SERVICE LETTER 172 8750A BULKHEAD 9 CRACKING

By: RCG	Aircraft Makes/Model(s): Cessna 208 Cessna 208B Quest Kodiak 100	Float Model(s): 8750A 7000A	Note(s): Mandatory Compliance Service Letter P/N 1008990
Approved: JRS			
Date: 11/30/2017			
Revision: C

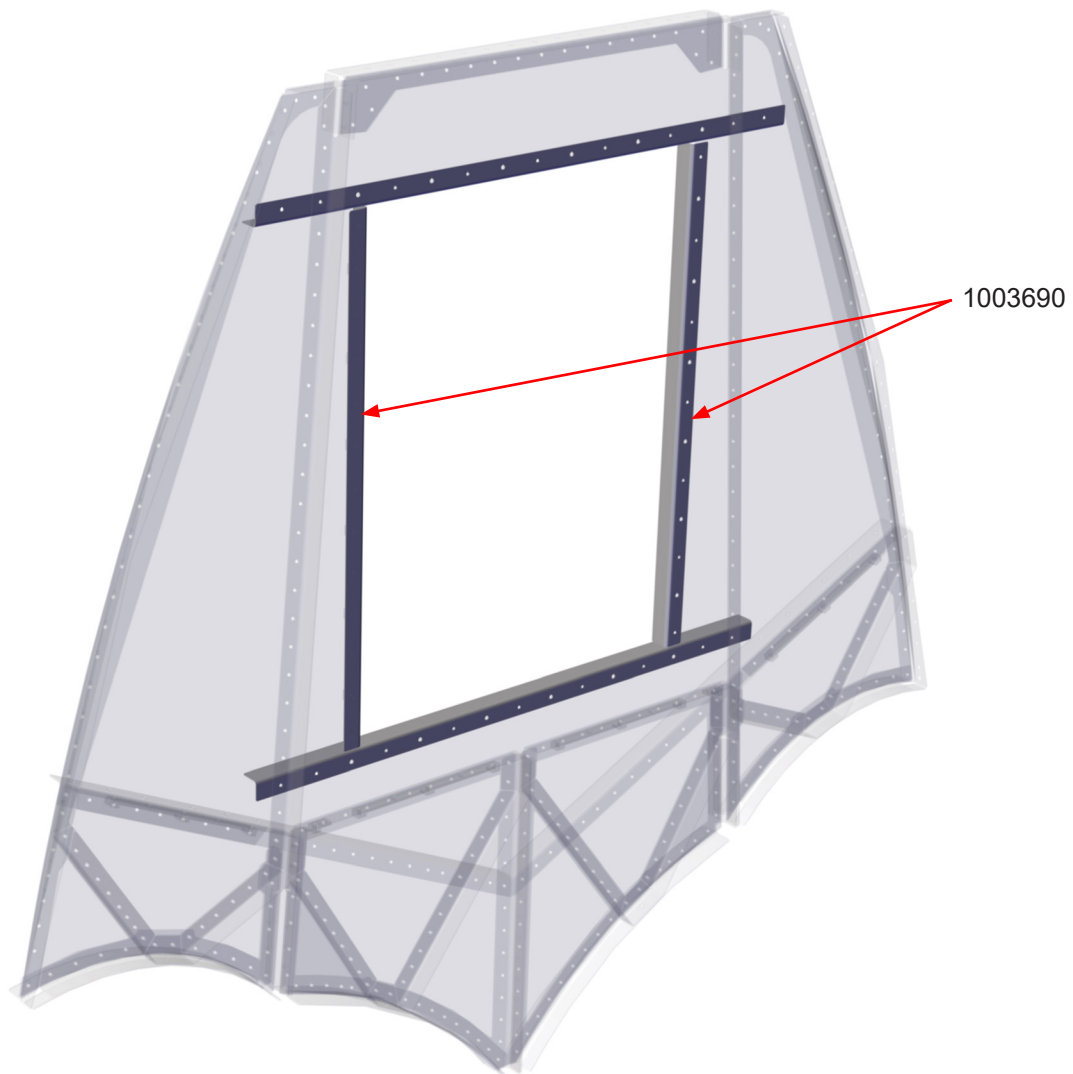
1. Gain access to the bulkhead 9 assembly through the aft baggage compartment and remove 1003688 Bulkhead 9 Access Panel. Discard (24) AN526-832R6 screws
2. Drill out (2) 1003690 Vertical Stiffeners

3. Inspect 1006080 Bulkhead Main Panel for cracking. If cracking is found, contact Wipaire Customer Service to receive additional instruction for repair. If no cracking is found, proceed to the next step

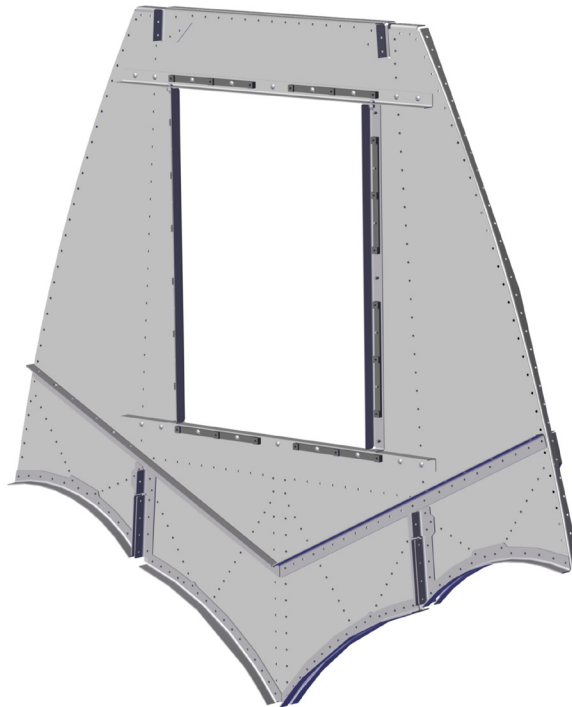
4. Remove (2) 1006513 Nylon Nutplates from each 1003690 Vertical Stiffener (4 total)
5. Position (2) revised 1003690 Vertical Stiffeners and (4) new 1006513 Nylon Nutplates where shown. Cleco in position and rivet Vertical Stiffeners and Nylon Nutplates to 1006080 Bulkhead 9 Main Panel

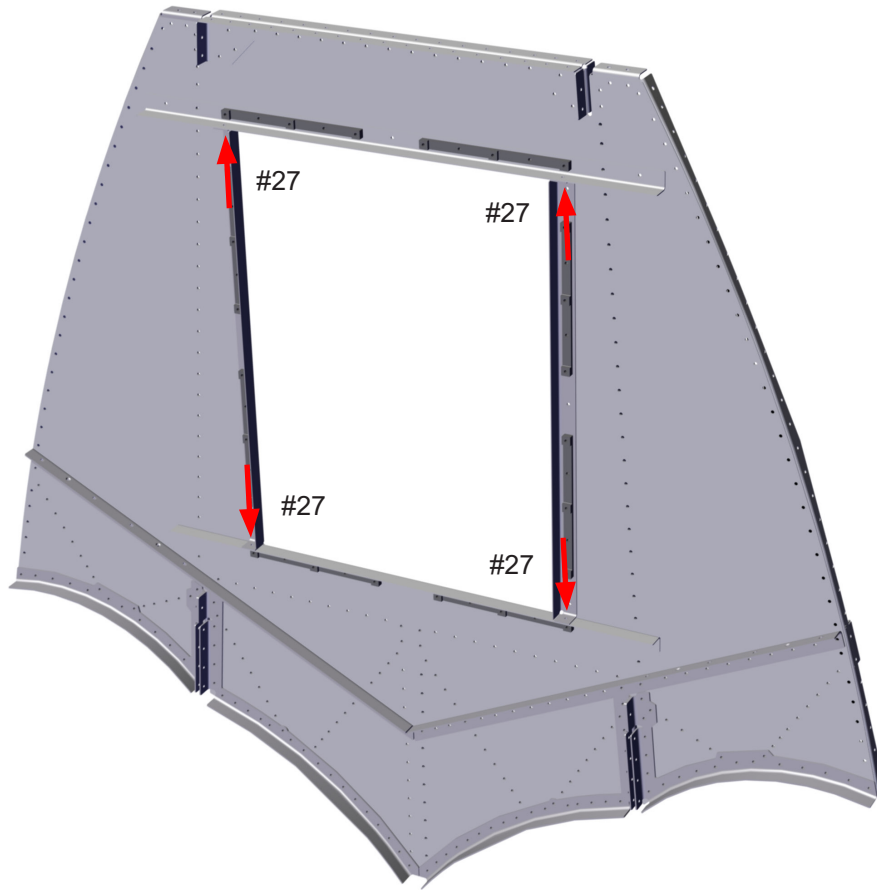
6. Backdrill through the 1003689 Horizontal Stiffeners in the 4 locations shown using a #27 drill bit

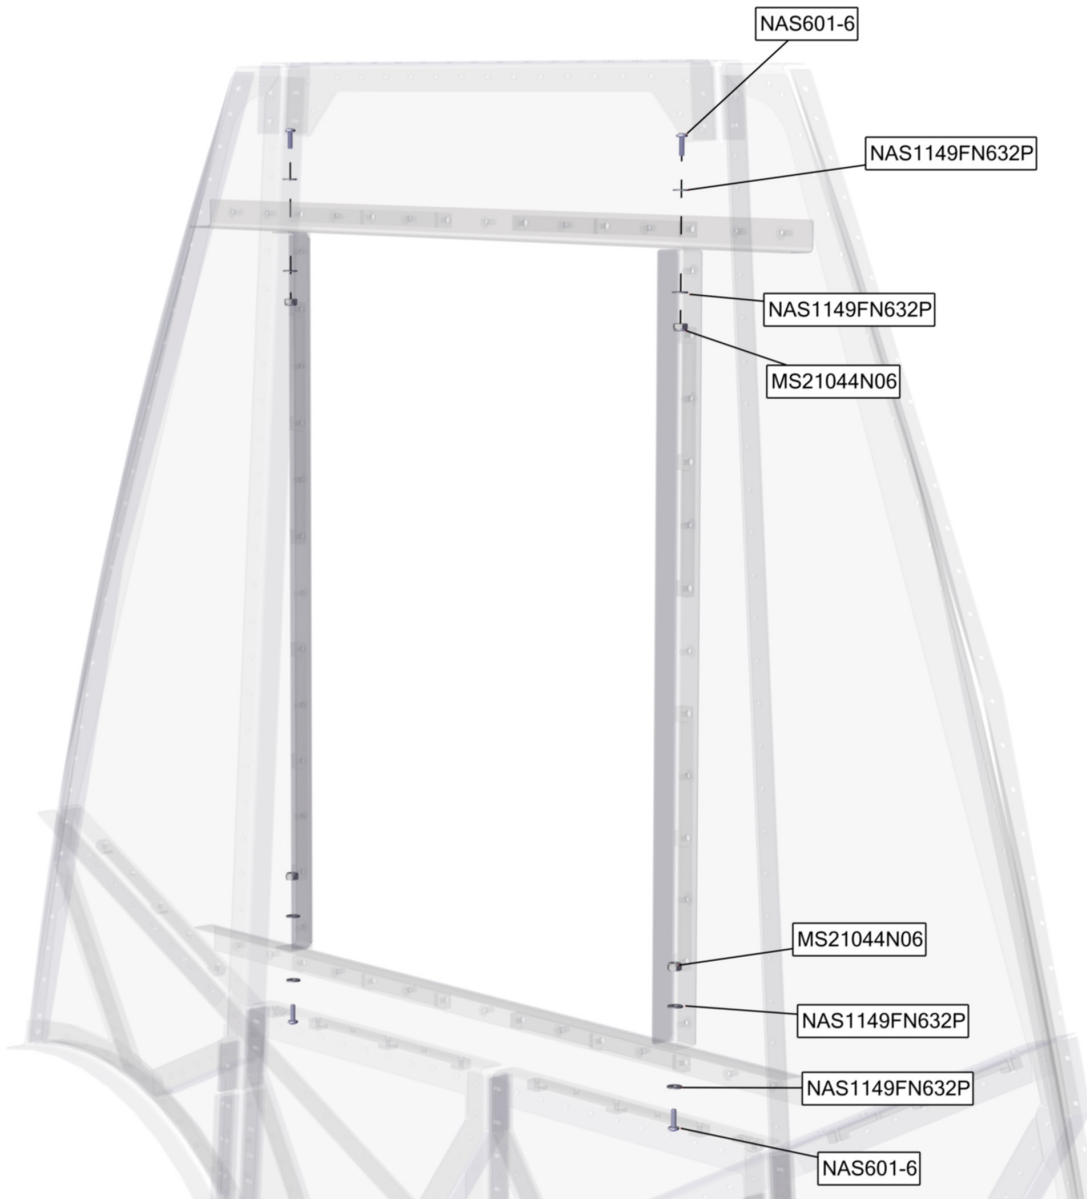
7. Install (4) NAS601-6 screws, (4) MS21044N06 nuts, and (8) NAS1149FN632P washers attaching the flange of each 1003690 Vertical Stiffener to the 1003689 Horizontal Stiffeners as shown

NOTE: Rivets may be used in place of the hardware if desired
